**ADDITION OF ACCESS ROADS UN-461-MOD, UN-461-MOD2, UN-642-MOD,  
UN-536-MOD, AND EXPANSION OF UN-461 WORKSPACE  
AMENDMENT DETERMINATION REQUEST**

**Boardman to Hemingway Transmission Line**

December 2025

**Figure 2. Resource Map - Proposed Change One**

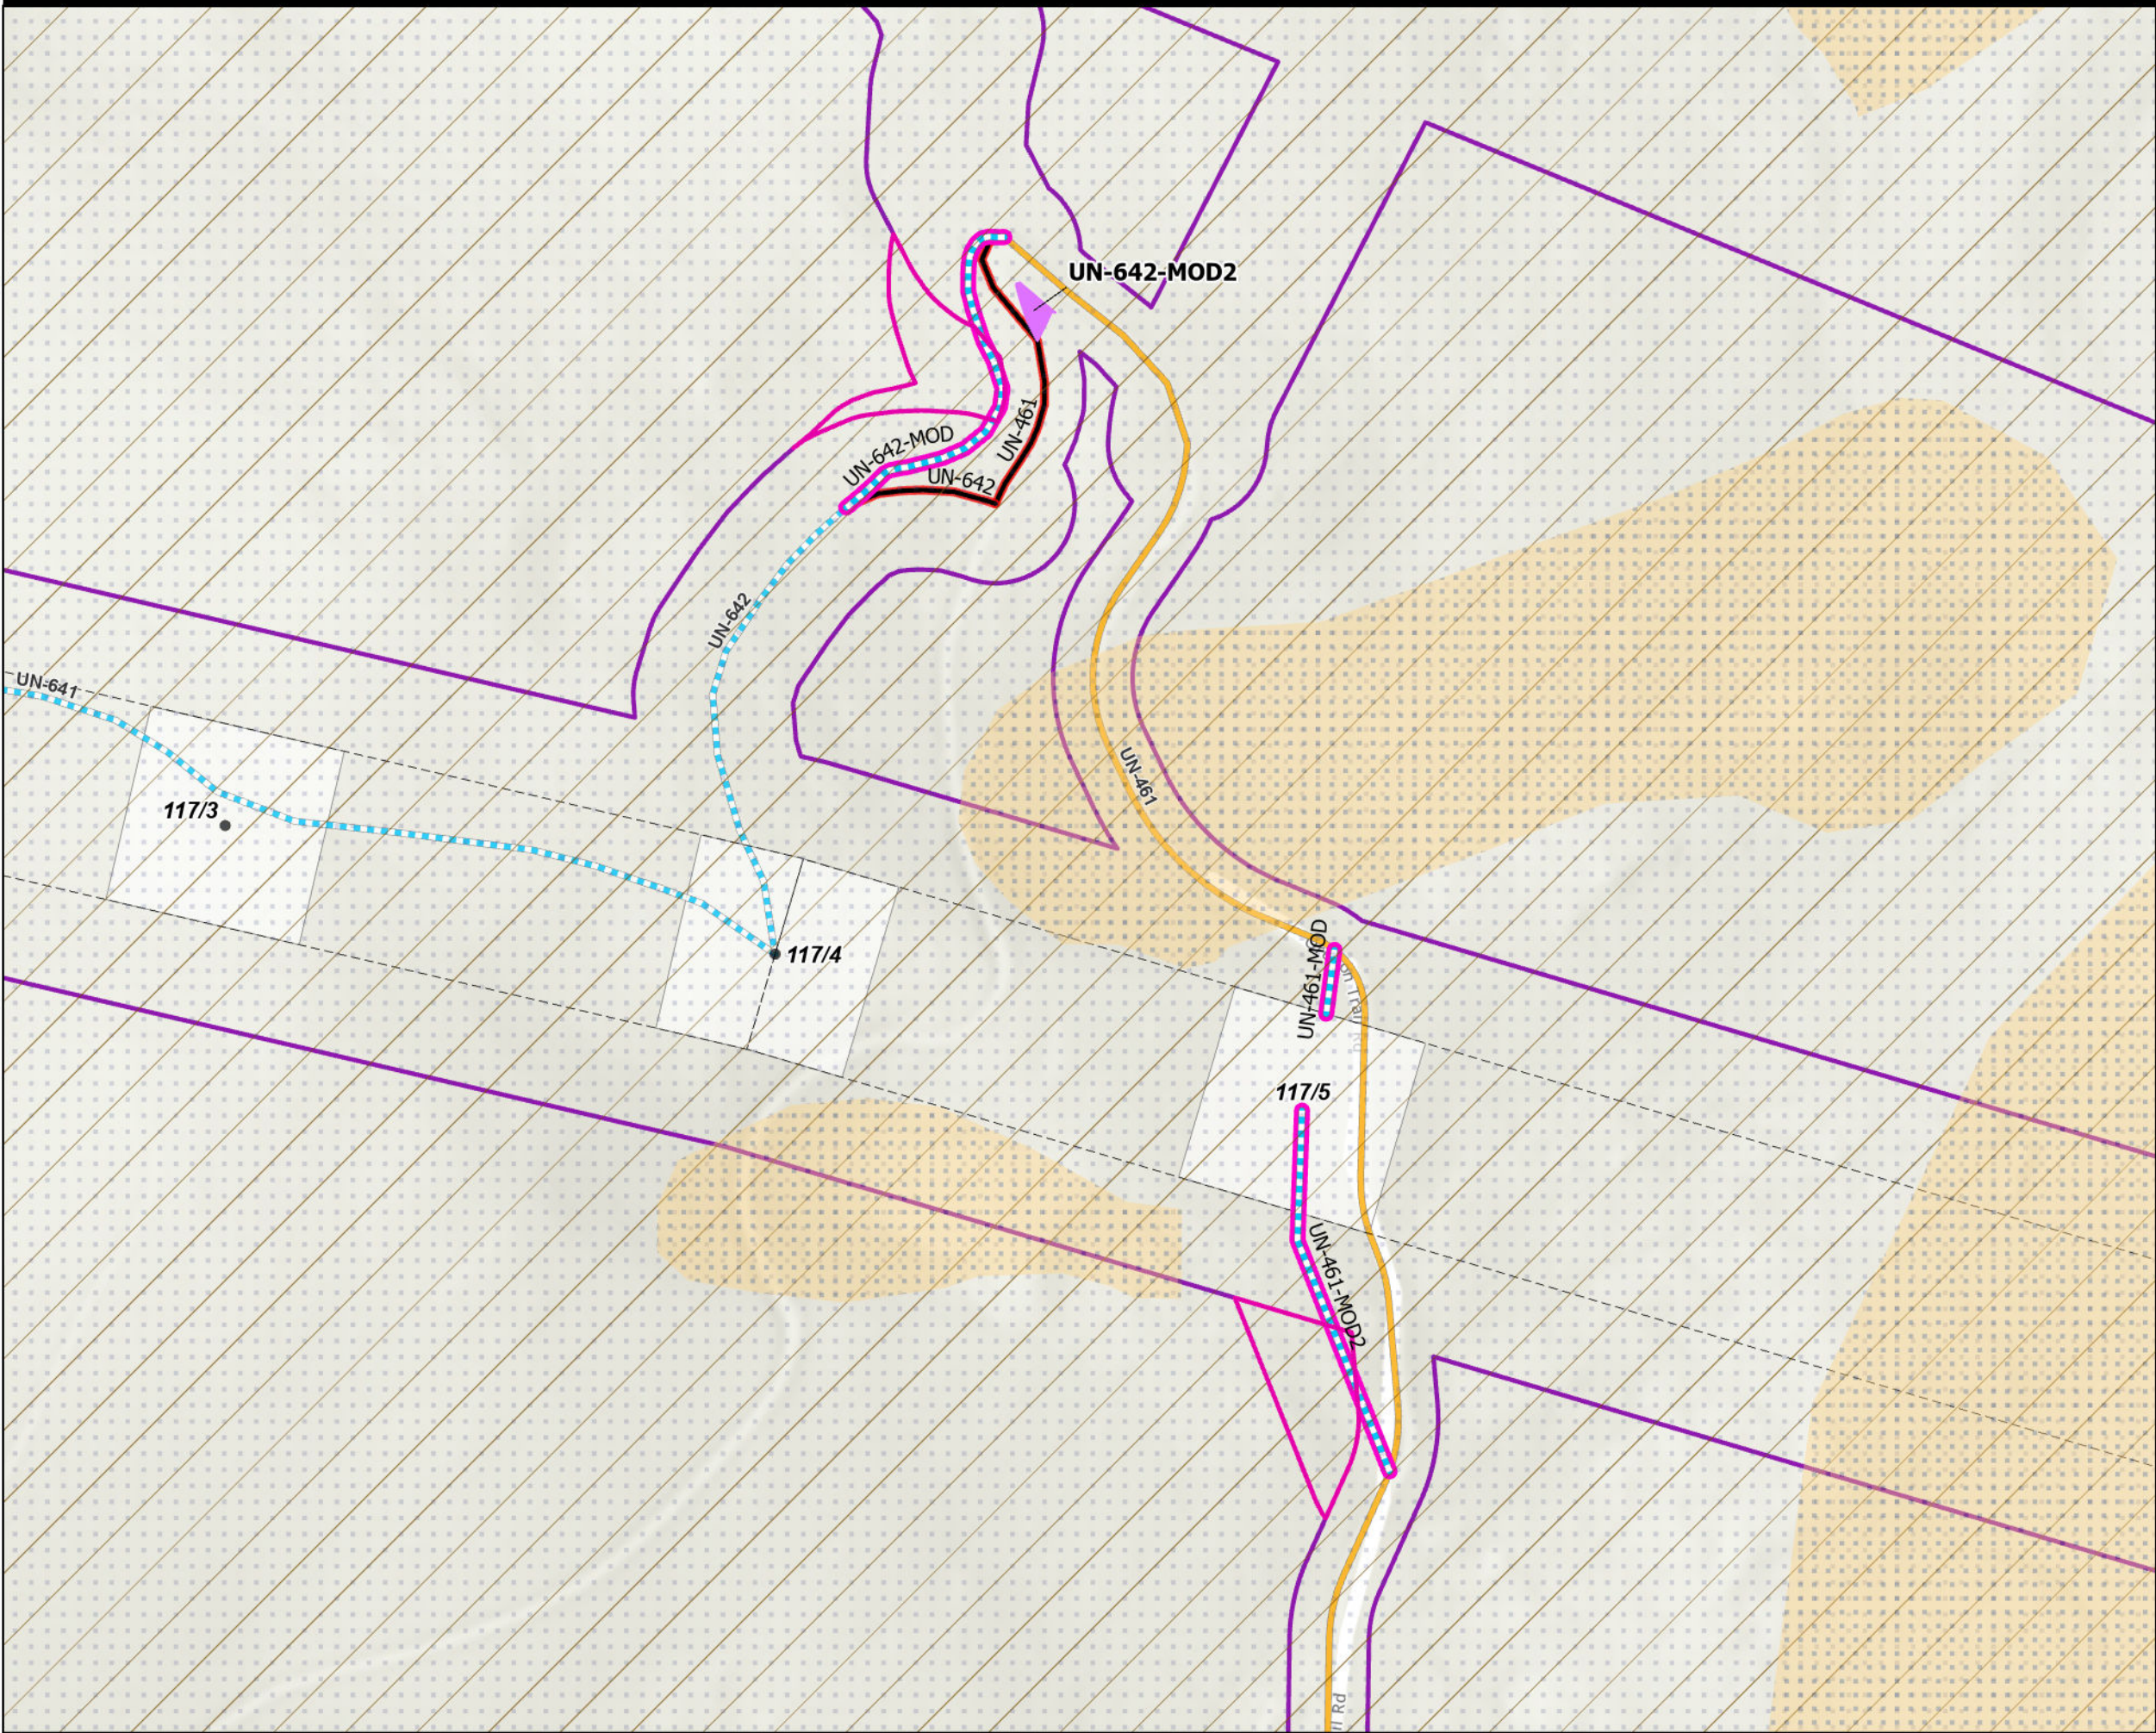
Proposed Change One would adjust the alignment of Access Roads UN-461 and UN-642 to allow construction vehicles to safely navigate a sharp turn north of Facility Structure 117/4 and 117/5 by adding Access Road UN-642-MOD and turn radius work space UN-642-MOD2, and retiring 390 feet of Access Road UN-461 and 200 feet of Access Road UN-642 made obsolete by the safer alternative. The proposed change would also add two spur access roads (Access Road UN-461-MOD and Access Road UN-461-MOD2) to provide safer access and workspace for foundation installation around Structure 117/5 where slopes are greater than 30%.

Proposed Change One is intended to provide safer access and workspace for construction and operation near Facility Structures 117/4 and 117/5 where steep terrain (30-40% slopes) and existing access routes are inadequate for safe navigation and construction. The addition of Access Road UN-642-MOD and workspace UN-642-MOD2 as an alternate route for portions of Access Roads UN-461 and UN-642 would create a wider turn radius that allows construction vehicles to safely navigate a sharp turn north of Facility Structure 117/4 and 117/5. Portions of Access Road UN-461 and Access Road UN-642 are made obsolete by the safer alternative and would be retired from the Facility.

Proposed Change One would also add two spur access roads (Access Road UN-461-MOD and Access Road UN-461-MOD2) to provide safer access and workspace for foundation installation around Structure 117/5. The proposed access roads would be classified as “New Road, Bladed” which would require cut and fill to create a smooth travel surface and manage stormwater runoff. As outlined in Table 5: Summary of Access Road Classifications in the Second Amended Site Certificate, construction of new bladed roads may include adjustments to the road prism or profile, consistent with EFSC-approved standards, and require a 120-foot construction disturbance width (due to slopes exceeding 30 percent) and a 14-foot operational disturbance width post-construction (EFSC, 2024).

**Figure 5. Resource Map - Proposed Change Two**  
**Boardman to Hemingway 500kV Transmission Line (B2H)**

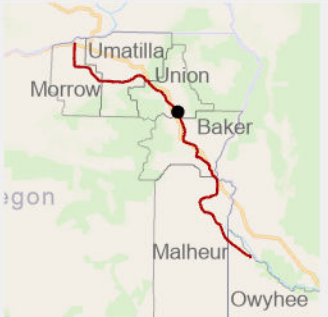
Proposed Change Two would shift Access Road UN-536 to avoid existing guy wires from a non-Facility transmission line, an obstruction not accounted for in the original design. The reroute would add 315 feet of new access road (Access Road UN-536-MOD) and retire a 350-foot portion of Access Road UN-536 that is blocked by the existing guy wires.

Proposed Change Two would provide critical construction and operational access to Facility Structures 127/4 and 127/5 by rerouting a portion of Access Road UN-536 to avoid guy wires attached to existing infrastructure and provide passable access for construction equipment. Proposed Access Road UN-536-MOD would be classified as “Existing, Substantial Modification, 21–70 Percent.” This classification applies to existing road prisms that require reconstruction to support safe passage for construction vehicles, including earthwork activities such as cutting, filling, and material placement to adjust the road prism and profile. Access Road UN-536-MOD would have a maximum allowable construction disturbance width of 25 feet (due to 0-15% slopes) and a 14-foot operational disturbance width post-construction as outlined in Table 5: Summary of Access Road Classifications of the Second Amended Site Certificate (EFSC, 2024).

Proposed Change Two also includes retiring 350 feet of Access Road UN-536 (“Existing, Substantial Modification, 21–70 Percent”) which would no longer be necessary due to the proposed alternate route.
